Nafa Apparels Ltd

Hijalhati, Bariopara, Kaliakoir, Gazipur, Dhaka
(+24.026926N, +90.239586E)

13 April 2014

Observations

3 Storey Factory – Column Stresses

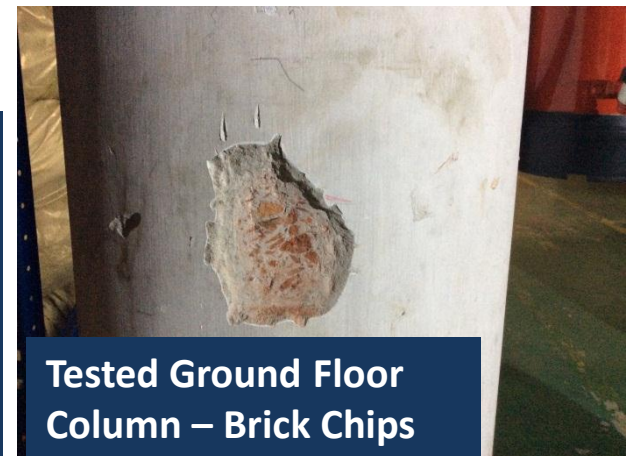
**Columns, within the 3 storey Factory Building
appear to be stressed in excess of normal
design limits**

Specific design check to be carried out on columns in 3 storey Factory

Cursory calculations indicate that columns are stressed in excess of normal design limits

Building Engineer is to perform detailed calculations and concrete tests to prove column size and (if required):

- Reduce loads by vacating floors
- Reinforce columns

Evidence of repairs to inclined columns at ground floor west side of Block A

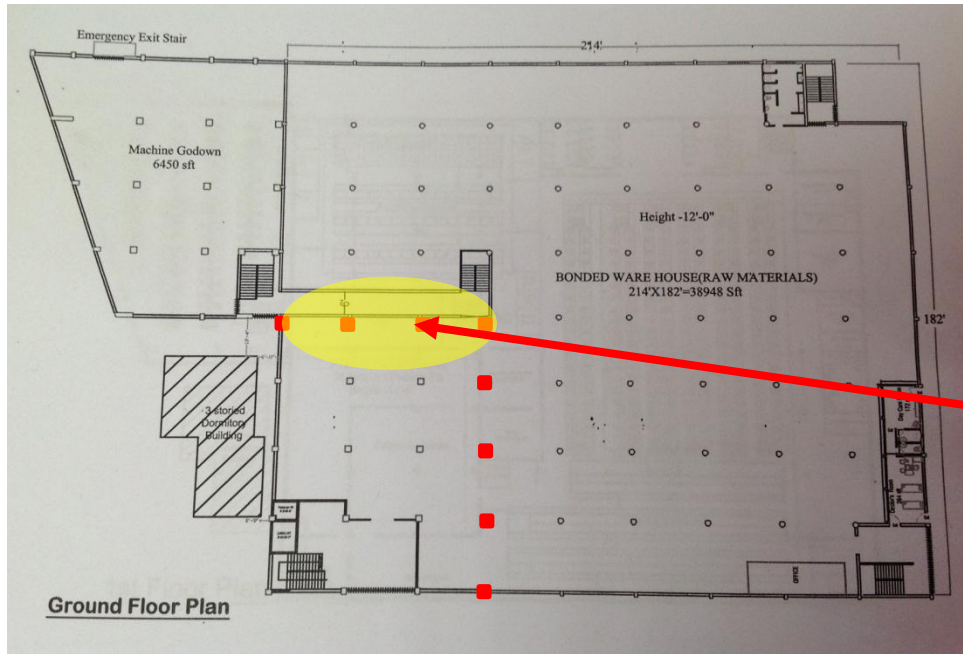
Evidence of repairs at base of inclined columns at ground floor west side of Block A

Evidence of repairs to base of inclined columns was noted in the highlighted area. Building Engineer to monitor and if cracks reappear – checks should be completed on the design and, if required, remedial measures should be carried out.

Steam and water at base of column

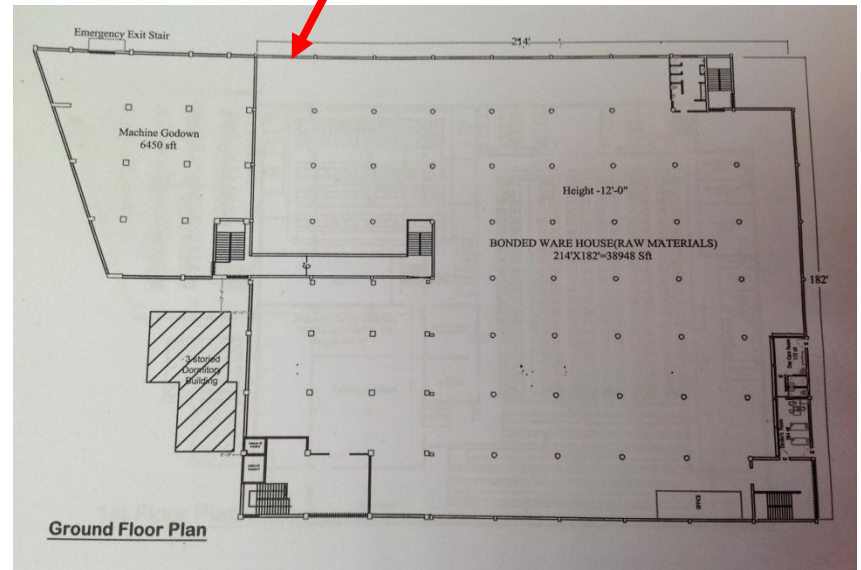
Steam and water drain at base of structural column

Steam outlet and open water drain at the base of a structural column. These should be diverted away from the building structure to avoid degradation over time.
